**FINDINGS AND RECOMMENDATION
OFFICE OF PLANNING AND ZONING
ANNE ARUNDEL COUNTY, MARYLAND**

CASE NUMBER: 2025-0234-V **COUNCIL DISTRICT:** 3

HEARING DATE: February 3, 2026

REQUEST

PROPOSED CONDITIONS PLAN

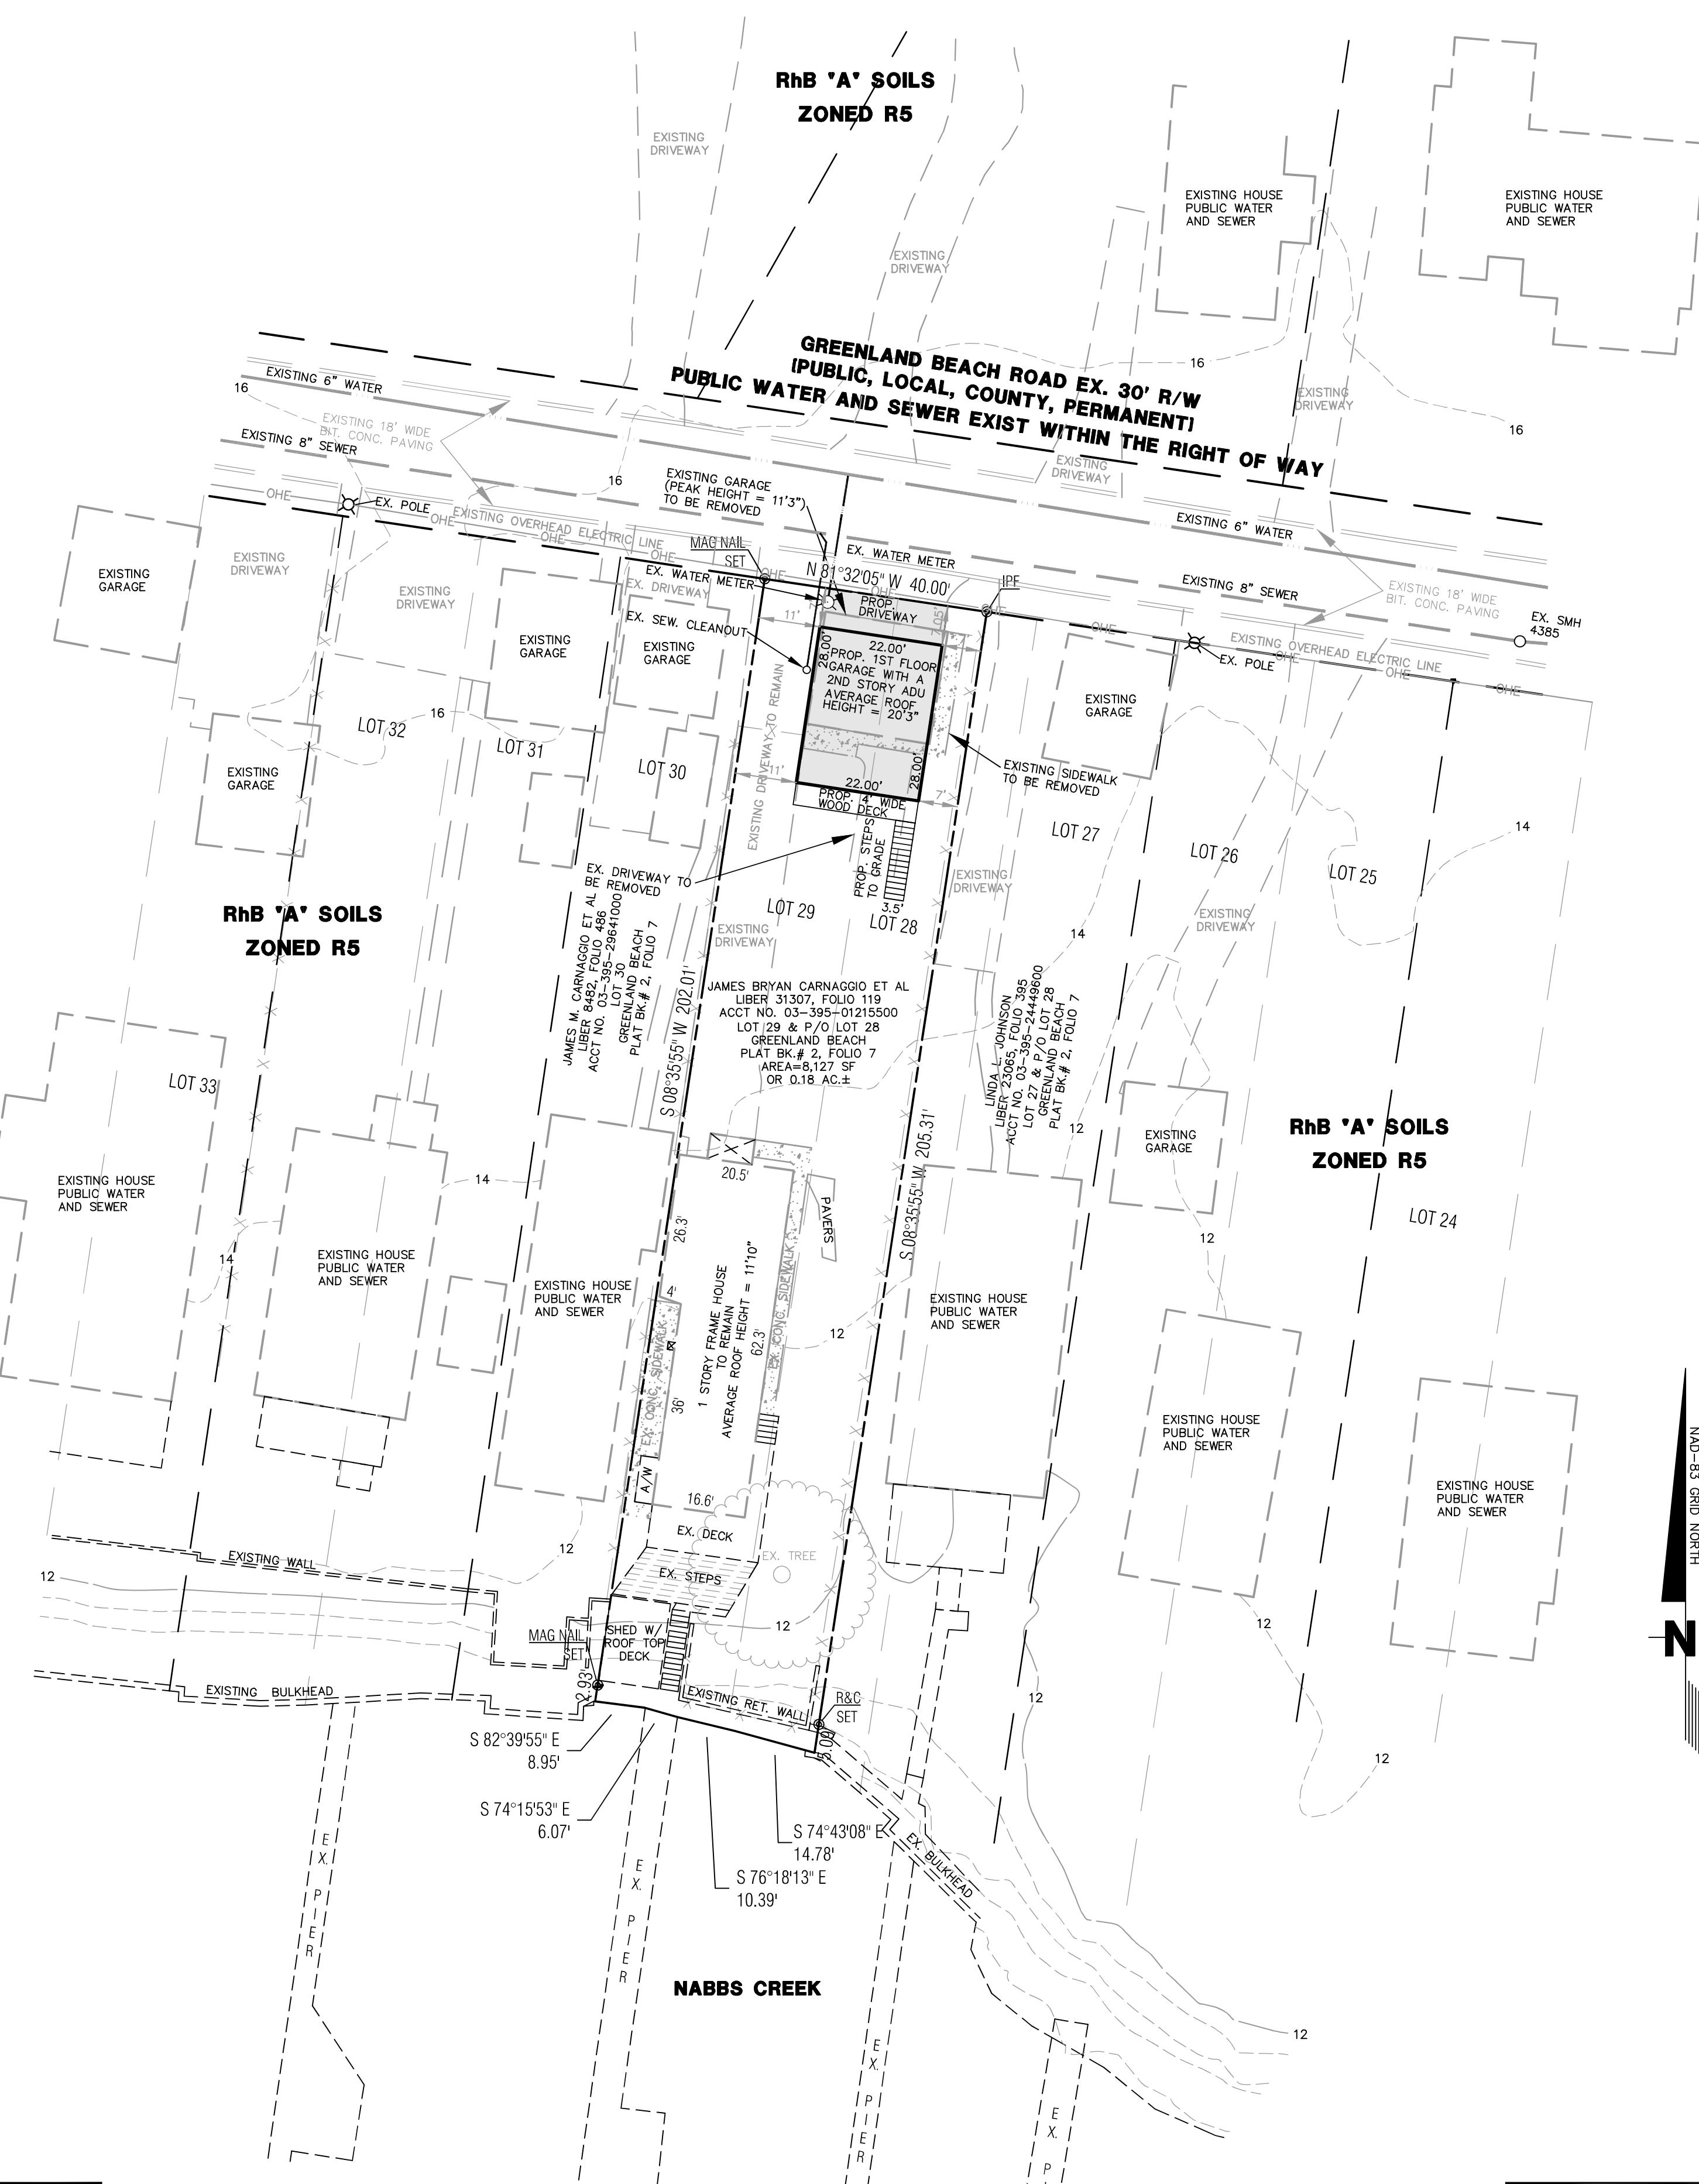
The Department of Inspections and Permits (Engineering Division): Show and label existing and/or proposed stormwater management devices. Show the access to the exterior steps. Show and label the existing water meter and sewer clean out locations.

Zoning Administration Section: It appears that the applicant can construct a one story detached ADU without the variance and still provide the desired home for the family member. The proposed structure seems excessive and is not likely to be supported by this Office. The site plan labels the proposed structure height as "peak height" and the existing dwelling height as "height". Please make sure the labels for the height of the structures are consistent and provides the height measurement required for the building permit.

- Show any access from the proposed garage to the existing driveway and/or house.
- Label the water meter and sewer clean out as to remain.

Response: There are no existing stormwater management devices to show. We will be required to address stormwater management with the building permit. Stormwater management will be addressed via planting for the increase of lot coverage. The sewer and water cleanout have been added to the administrative site plan. Construction plans have been submitted as part of this application. These plans show access to the outside steps.

Response: We feel this proposed garage/adu is modest in size when we take into consideration that we still need the 2-off-street parking space that the existing garage provides. This lot is only 40' wide at the right of way. This limits the area to park cars. The existing driveway needs to access the existing house so no parking can happen along the side. This is the need to build the garage with the adu on top. The average roof height has been provided on the site plan.

The peak height is called out for both structures.
